**PLANNING COMMISSION REPORT  
NON PUBLIC HEARING ITEM**

**ITEM NO. 5C PRELIMINARY PLAT FOR NAISMITH CREEK ADDITION; 751 W 29<sup>TH</sup>  
TERR (SLD)**

**PP-16-00221:** Consider a Preliminary Plat for Naismith Creek Addition, for 66 single-dwelling residential lots, located at 751 W 29<sup>th</sup> Terrace. The subdivision will take access from Alabama Street and W 29<sup>th</sup> Terrace east of Belle Haven Drive. Submitted by Landplan Engineering, for Savannah Holdings, LC, property owner of record.

**Figure 2: Utility Easement Map**

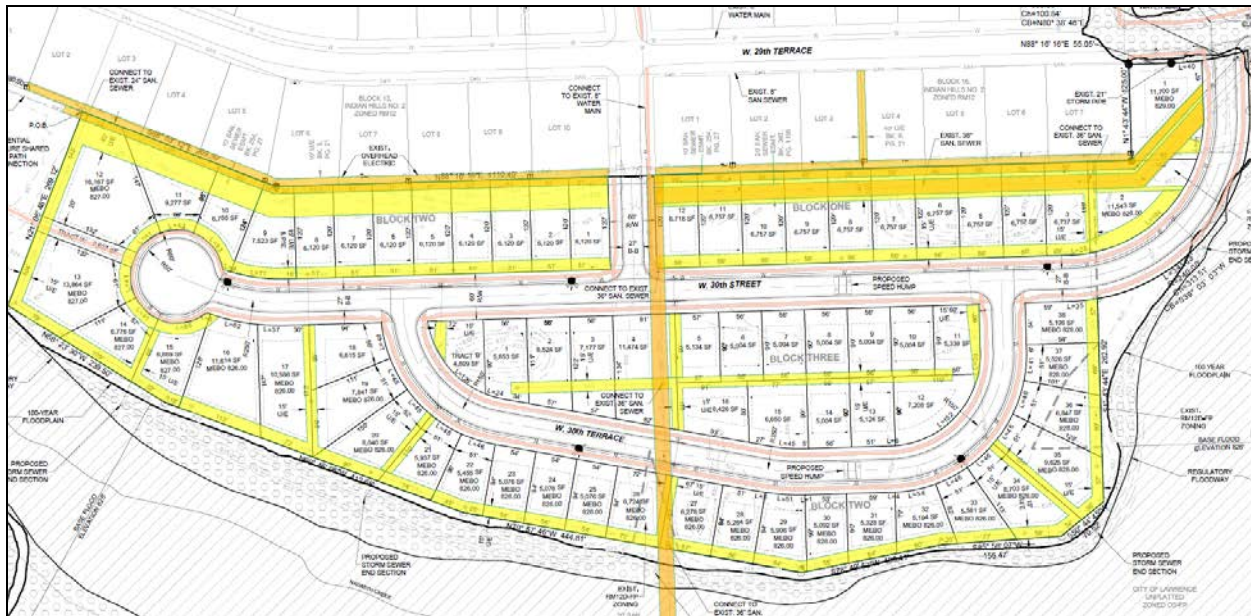
The city is working on the Naismith Valley interceptor sewer that will be installed along the north property line and result in the removal of Pump Station #8. The proposed preliminary plat shows a 40' wide utility easement along the north property line. The improvements have not been designed the easement width is based on a maximum possible improvement. Depending on the final design the easement could potentially be reduced. Staff has made the applicant aware of the design options and will continue to communication with the applicant/developer as design decisions are finalized. There is a possibility that the easement width could be reduced.

City Staff noted that the north portion of the property included existing "sanitary sewer easements." These easements are exclusive and do not accommodate any other utilities. The proposed preliminary plat shows a new 40' utility easement that would overlap the existing exclusive easements. City Utility Staff commented that the proposed 40' utility easement should be for the exclusive use for sanitary sewer. The proposed Preliminary Plat shows this exclusive easement.

A general utility easement located along the north side of W. 30<sup>th</sup> Street would allow for other utilities in addition to the proposed sanitary sewer along the front of the lots. This orientation typically has the effect of pushing street trees to the back of the utility easement. The proposed plat anticipates that street trees could be located between the sidewalk and the property line, within the street right-of-way. Maintaining adequate separation of trees and utilities will be required during utility construction and tree installation. Additional review of utility easements will be

715 W. 29TH TERRACE  
LAWRENCE, KANSAS 66046  
A PRELIMINARY PLAT FOR  
NAISMITH CREEK ADDITION

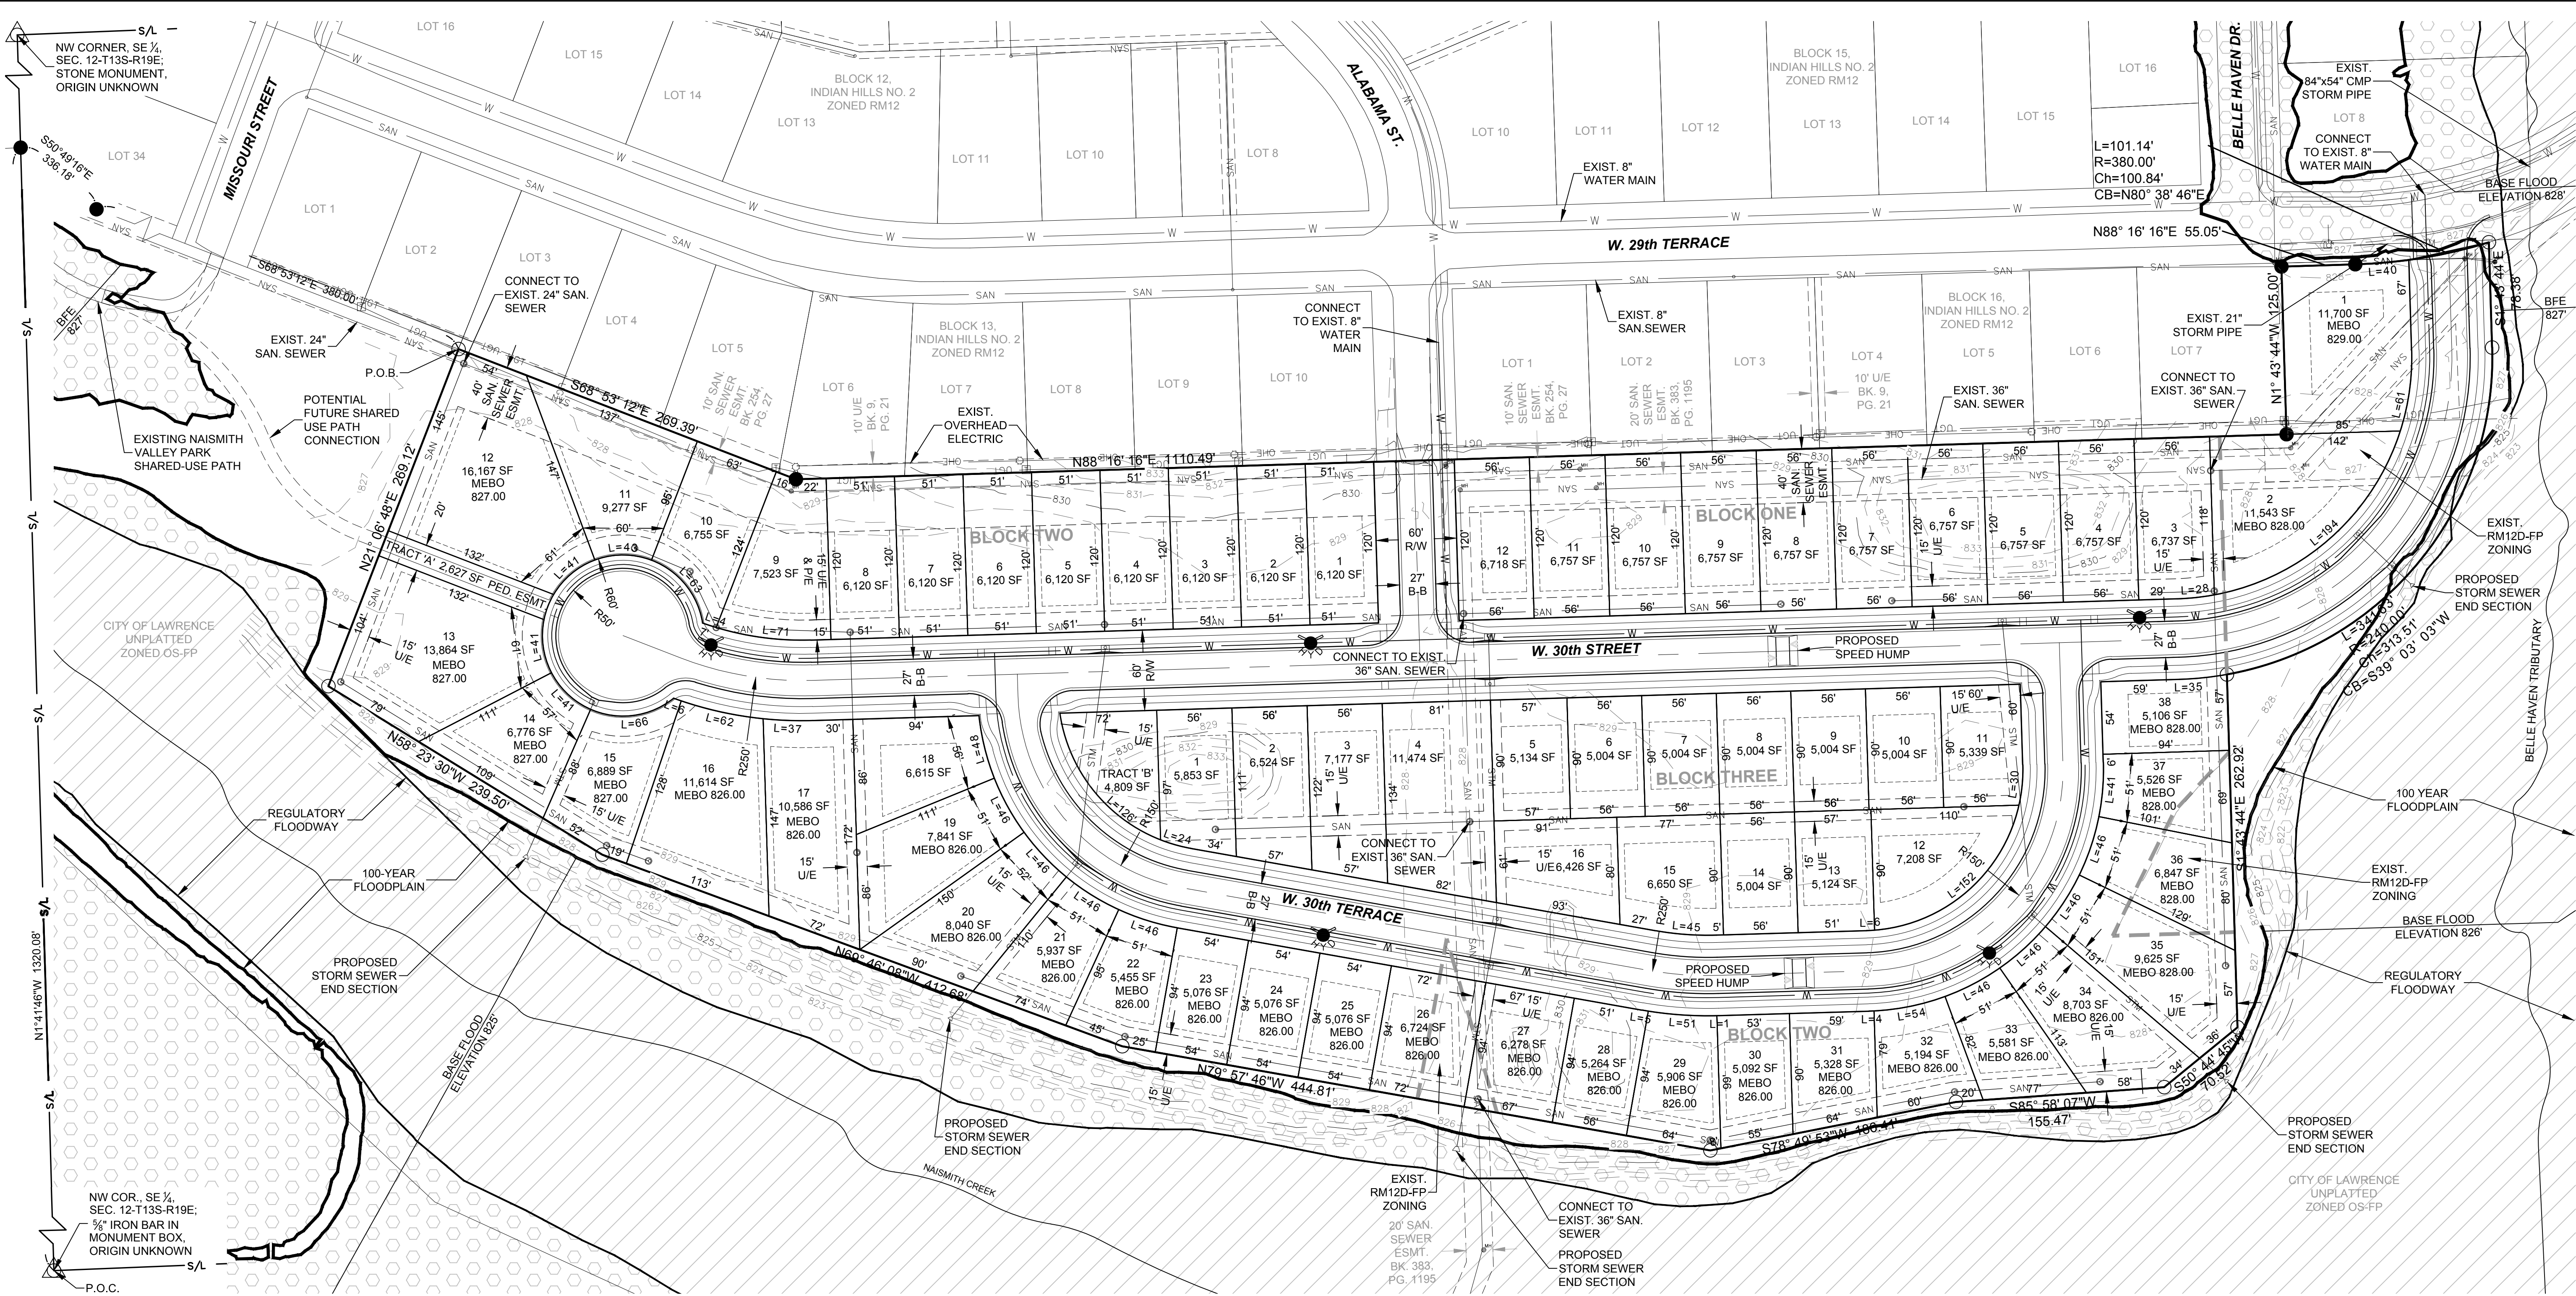
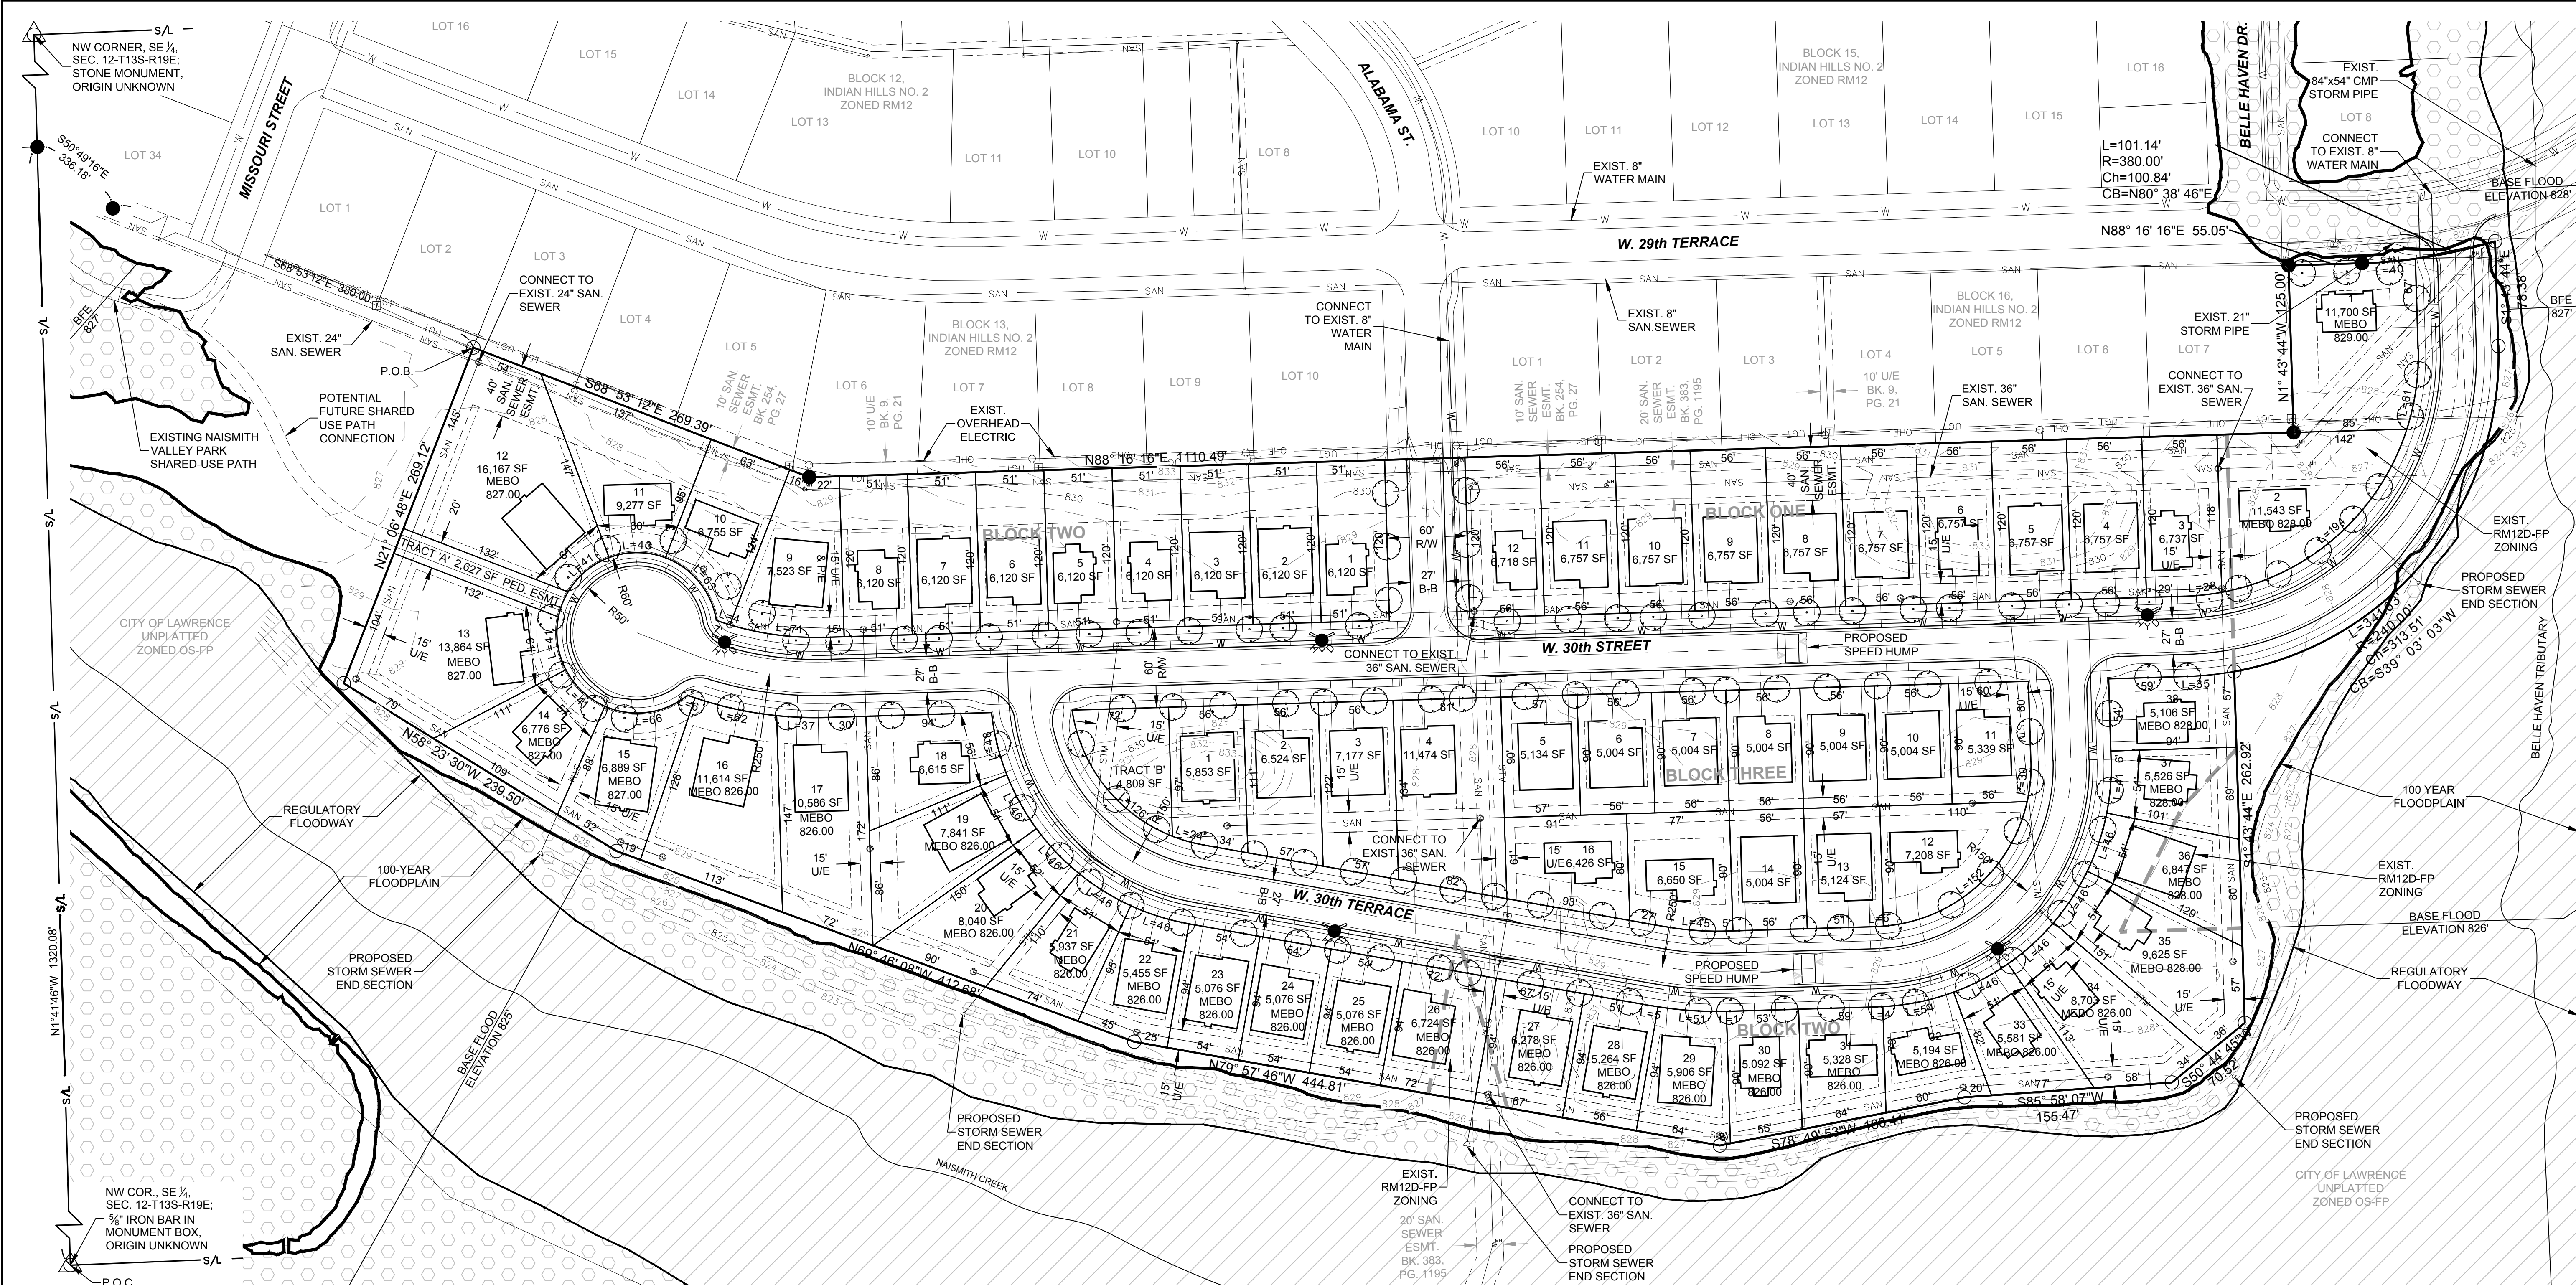
1. Provision of a revised Preliminary Plat with the following notes and changes:
  - a. Differentiate between existing and proposed contours lines (indicate where existing topography is changing) per the approval of the City Stormwater Engineer.
  - b. Show additional traffic calming per the City Traffic Engineer's approval.

Lots adjacent to all drainage easements and the regulatory floodplain are required to note the minimum habitable floor elevation of the structure. This information is shown on the face of the preliminary plat. Additionally the Preliminary Plat shows the required notation per section 20-809 (5) (ii) (c) that states: *"If a basement is built on a lot where a minimum elevation has been established, the building design is encouraged to incorporate a sump pump."*

The League of Women Voters of Lawrence-Douglas County is concerned about the proposal for Naismith Creek Addition, which would create 65 single-dwelling residential lots on approximately 15 acres adjacent to Naismith Creek. One of our important Environmental Positions is that "development should avoid hazardous building sites such as unstable slopes, uncompacted or undesignated fill, or areas subject to flooding."

The plat does not comply with Subdivision Design regulations, which require that a drainage plan be shown. The plat should show "Location of any area in the Floodplain Overlay District, locations and direction of flow of all water courses; and base flood elevation at water course entrances to and exits from the proposed Subdivision."

I – If the southern-most line of lots from at least lots #20 through #34 would be eliminated, not only would this allow the open space to be available for the smooth continuation of the Naismith Valley Park and Bike
